Engineering Referral Response

Application Number:	Mod2023/0230
Proposed Development:	Modification of Development Consent DA2022/0717 granted for Demolition works and construction of a mixed use development comprising self-storage units and industrial units including lot consolidation
Date:	20/07/2023
To:	Alex Keller
Land to be developed (Address):	Lot 1 DP 1284167 , 101 - 105 Old Pittwater Road BROOKVALE NSW 2100

Image: Amended design 12.7.2023.

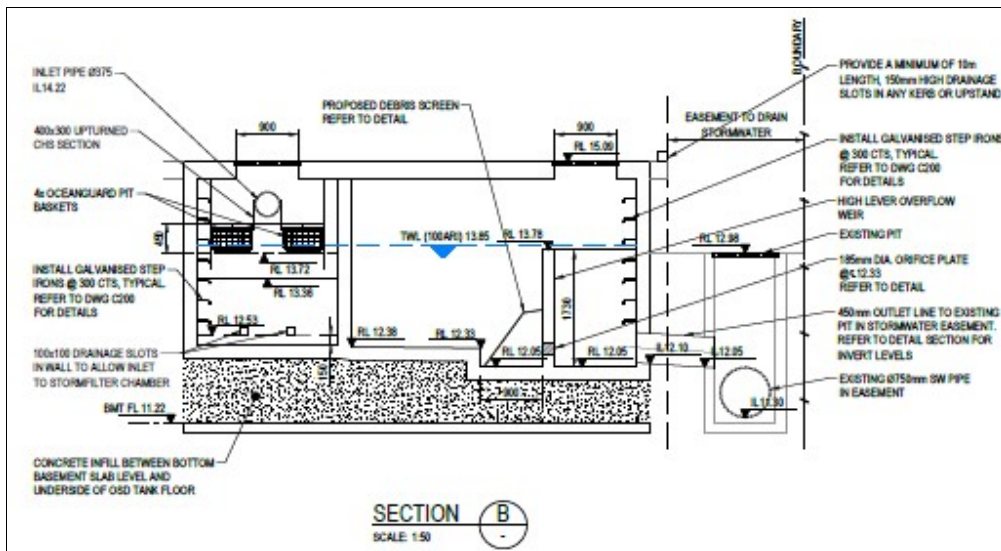
The revised drawing 21W12_S4.55_C201 rev 02 dated 12.07.2023 by henry & hymas shows the proposed pipe invert level of the OSD connection to Council's system raised to be at the level of the obvert of Council's 750mm stormwater pipe, which is acceptable. This drawing along with the other drawings in TRIM record 2023/441159 should replace the existing engineering plans listed under condition 1 of development consent for DA2022/0717. Condition of consent 25 -On-site Stormwater Detention Details should be amended to reference revised engineering plans. It is advised that all other existing engineering conditions of consent should be retained. As per existing conditions of consent, the development will require a Section 68 application for connection to Council's stormwater system. I have no further objections to the proposal.

Image: OSD connection.

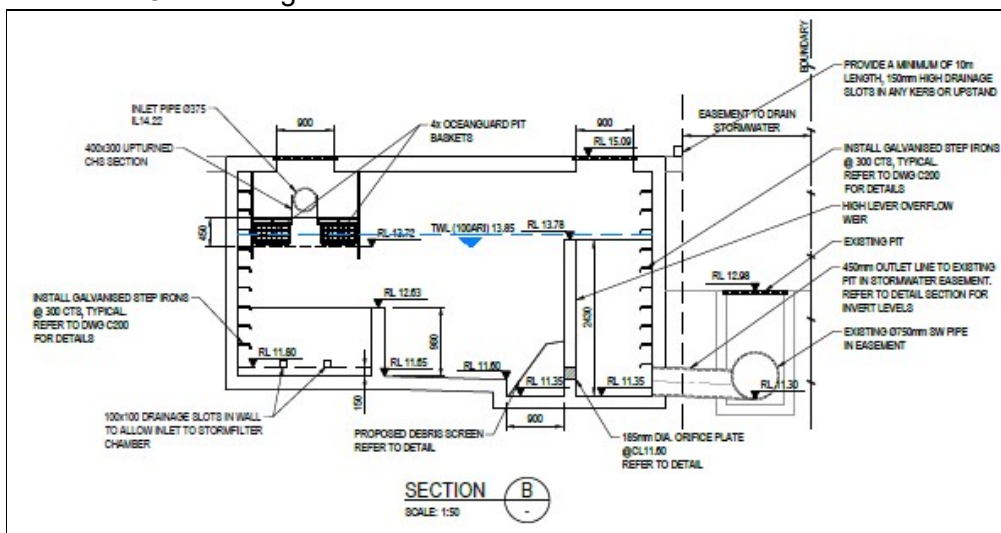
The following amendments are required to Drawing No. 21W12_S4.55_C201 rev 01 in order to lessen the impact on Council infrastructure.

Section B. The invert of the outlet pit (RL11.35) is to be raised above the obvert level of Councils 750mm easement pipe and provide 50mm fall in the proposed 450 mm pipe and maintain the calculated OSD storage volume.
